SUBJECT: **To set Public Hearing for Final Site Plan & Special Land Use Permit at 260 N. Old Woodward – Au Cochon and Arthur Ave.**

SUBJECT: **Final Site Plan & Special Land Use Permit Review**
260 N. Old Woodward – Au Cochon and Arthur Ave.

SPECIAL LAND USE PERMIT ("SLUP")
FINAL SITE PLAN REVIEW
260 N. Old Woodward Ave.
Au Cochon and Arthur Ave.
Renovation of the former Chen Chow restaurant into two new restaurants with a shared kitchen and shared office facilities

SHEET #
SP.101

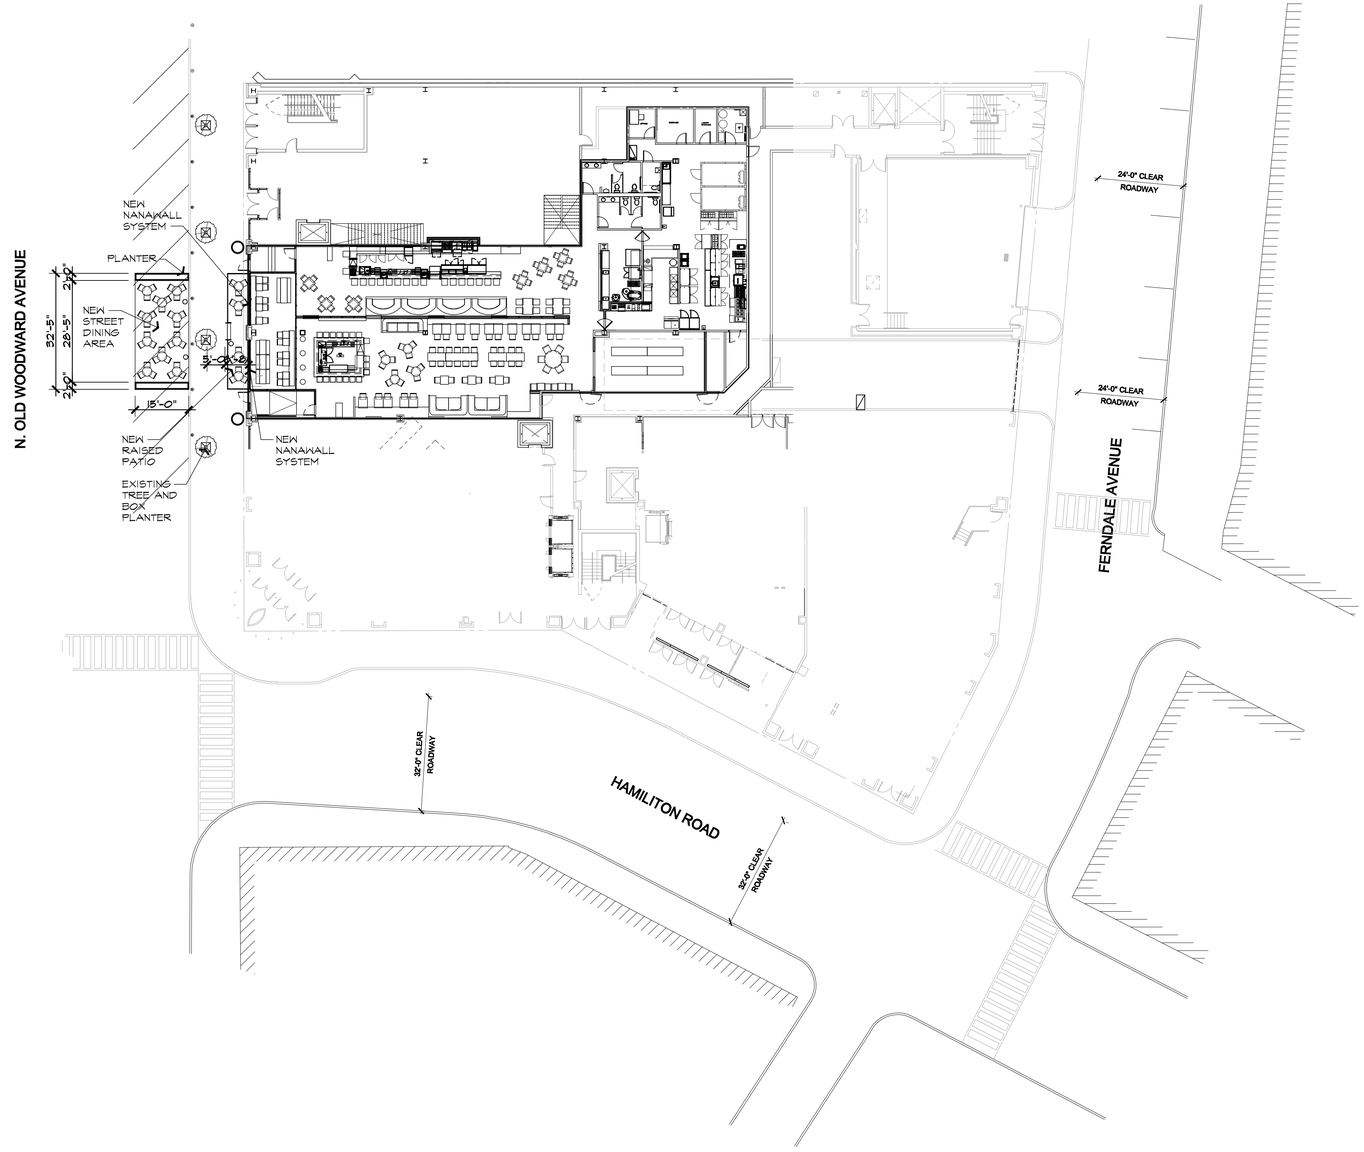
Regarding platform:
1. The platform must be redesigned to make better use of the space available, and not impede into the parking space on the south side. That parking space should remain as parking. Likewise, it appears that some additional space could be gained to the north without using more spaces, in front of the vestibule door. It is recommended that this change be made before submitting plans for consideration by the Advisory Parking Committee. The next deadline for them to be seen at their next meeting is Feb. 12.

2. Planters are proposed along the north and south edges. We cannot endorse planters in these areas as they are an unnecessary sight distance hazard. It is already difficult pulling out from the parking space to the north of this deck, and healthy plants acting as a screen wall in this area would make it worse. The railing should be installed to keep people on the deck, but not screen them above 42 inches.

Regarding sidewalk:
1. The Engineering Dept. does not endorse the use of the tree grate as part of the minimum 5 ft. wide sidewalk left open for the public.

2. The existing sidewalk was scheduled for repairs last summer, but was postponed per the request of the building owner due to the upcoming building renovation. The owner must complete all needed sidewalk repairs in this area before the deck is set up.

The dining deck proposed on the street will occupy 4 parking spaces, and thus the applicant must appear before the Advisory Parking Committee for their review and recommendation. The proposal has been reviewed by the Engineering Dept. and they have stated that they have no objections to the platform as proposed. Ten three-top tables and 30 chairs are proposed on the on street dining deck. The tables proposed are Range Opera round steel tables by FERMOB and are 26" diameter, in Anthricite (dark grey/black). Range Louvre stacking armchairs 0802 by FERMOB are proposed, which have a steel frame with perforated 18" wide steel sheet seats. The chairs are proposed in Chili (dark orange/red). The proposed layout shows one trash receptacle on the outdoor dining deck in the street. **However, no specification sheets have been provided for the trash receptacle proposed.**

Both outdoor dining decks will be shared between the two restaurants. The required 5' clear pedestrian path has been provided on the public sidewalk between the two outdoor dining decks. The 2016 Plan recommends that this pedestrian path be immediately adjacent to the storefront to allow pedestrians to see into the storefront and to have a consistent and unobstructed walkway. However, the Planning Board has discussed where the location of the pathway should be located (next to the building or closer to the street) and have chosen to review each proposal individually to determine the most logical location based on the current flow of pedestrians.

1. **The applicant execute a contract with the City outlining the details of the proposed restaurants;**
2. **Reconfigure the on-street platforms in accordance with the direction of the Advisory Parking Committee;**

3. **Repair sidewalk as required by the Engineering Dept.;**
4. **Provide specification sheets for the proposed service station and trash receptacle;**
5. **The applicant provide full details on the heights of the railings, spacing, and load specifications, and clarify which material will be used for the outdoor dining deck platforms;**

7. **The applicant provide minimum 5 ft. barrier free clearance on the sidewalk; applicant may use tree grate towards their 5 ft.; and**
8. **The applicant meet all departmental requirements.**

SHEET #
A.201

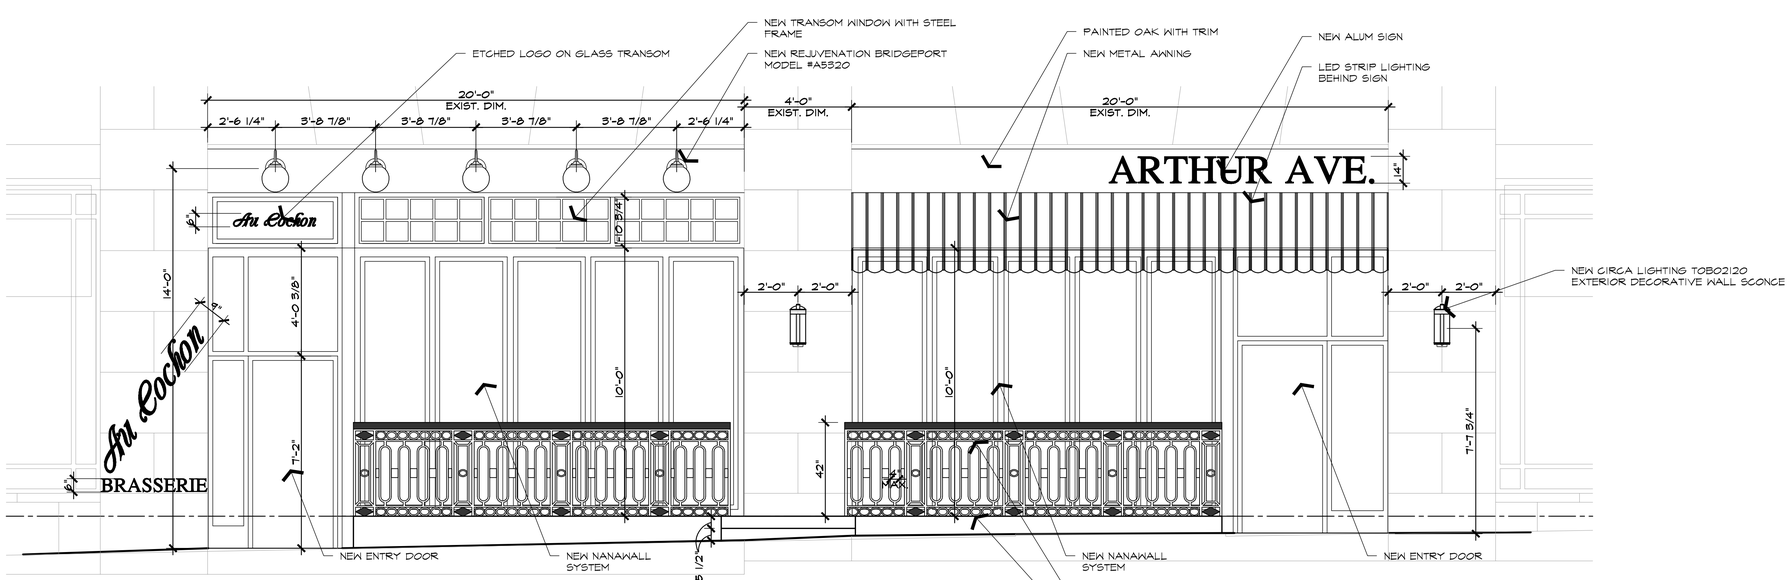
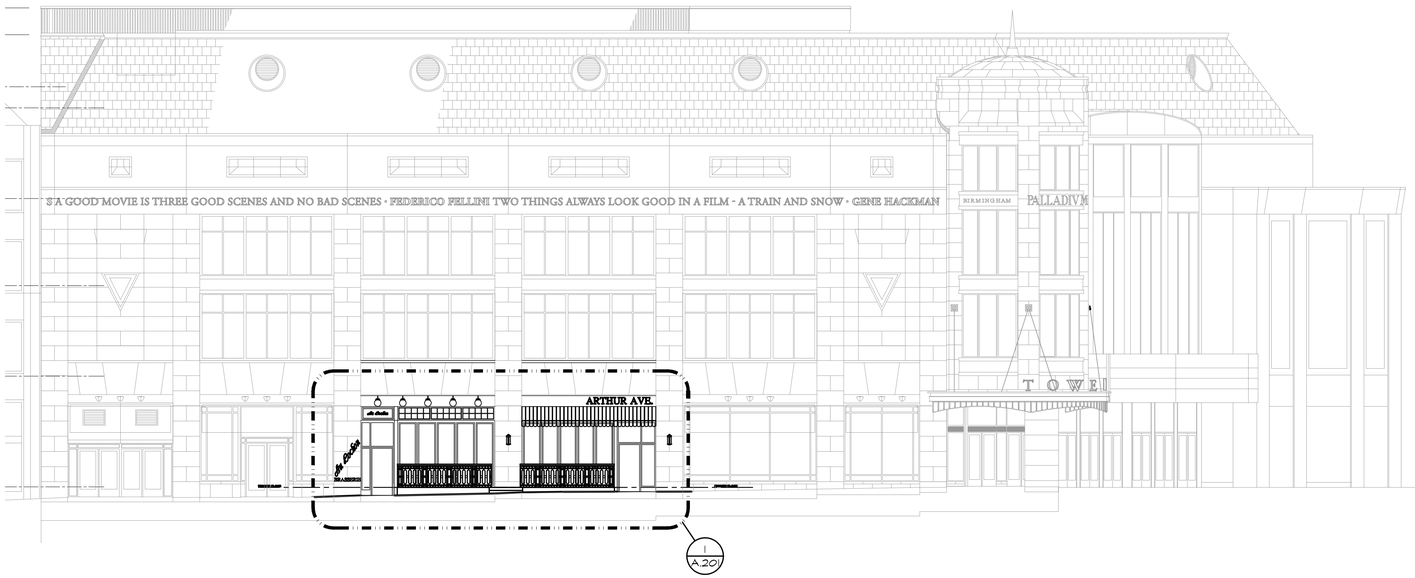
individual storefront façade for each of the two new restaurants. **The applicant has not provided the paint color for the storefront Oak panels that will extend across approximately 52' of the first floor of the existing building.** The following design changes are also proposed to create unique storefronts for each of the new restaurants:

also proposed underneath to be in block letters 0.5' in height and 4' across (2 square feet), also to be pin mounted to the new façade. This signage is not proposed to be located in the sign band, but rather at pedestrian level adjacent to the entry door of the restaurant. This proposed signage is within the total sign area allowed (maximum of 44 square feet), is compatible with the building's street design and is mounted at pedestrian level thus adding interest to the streetscape and adhering to one of the primary goals of the 2016 Plan. Mounting this signage on the sign band would not provide for a distinctive and separate look from the adjacent restaurant.
